<b>Standard Modification</b> Issue 1	Mod No. SM 12781
		Page : 1 of 2
		Compiled : A Draper
		Approved : F Donaldson

## TITLE : Installation of Fuel Tank Drains

APPLICABILITY : **All Tecnam Sierra variants**

File off shaded area (both sides)

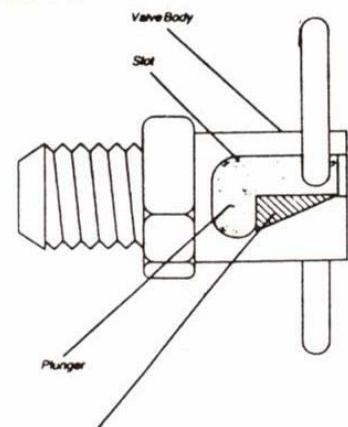
- 3.2 Drill carefully to minimise the chance of swarf from entering the tank and, following drilling, ensure that all swarf is removed from the tank.
- 3.3 Before installing the Curtis drain valves, file away the portions of the valve body that act to latch the valve in the open position. See illustration.
